Serial No.: 10/648,012

Amdt. Dated: March 14, 2006

Amendments to the Drawings:

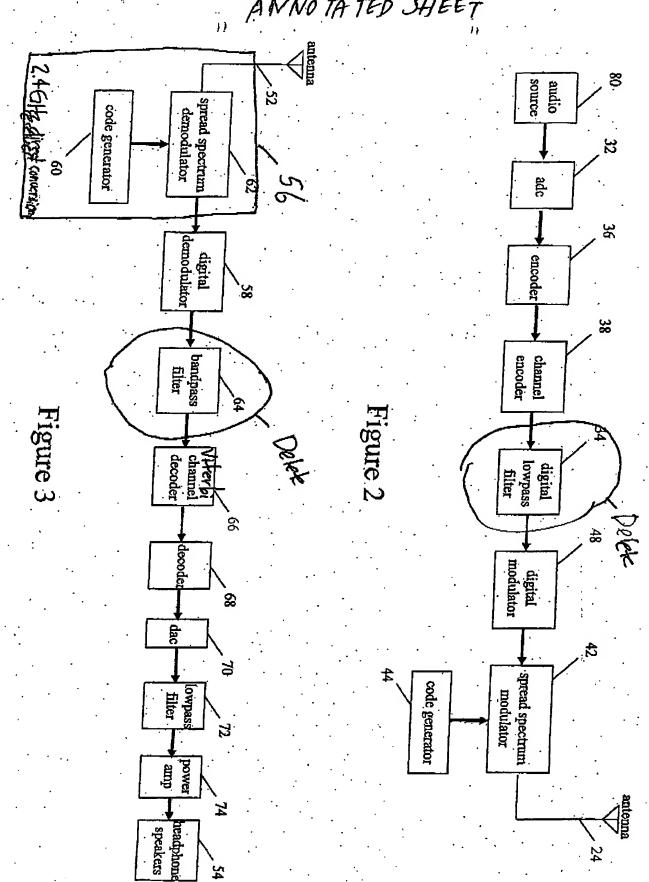
The drawings were objected to as incorporating new matter because of the altered

order of the filter in relation to other elements. Corrected drawings were required

because of the altered order of the filter in Figs. 2 and 3. More particularly, with respect

to Fig. 2, the low pass filter was shown between the ADC and encoder, thus differing

from the drawings in the parent application. With respect to Fig. 3, the bandpass filter

was shown in a different order from that shown in the parent.

In order to expedite matters, Applicant has deleted the low pass filter of Fig. 2 as

well as the bandpass filter of Fig. 3. These filters are often included with analog-to-

digital converters and demodulators such as those shown in Figs. 2 and 3.
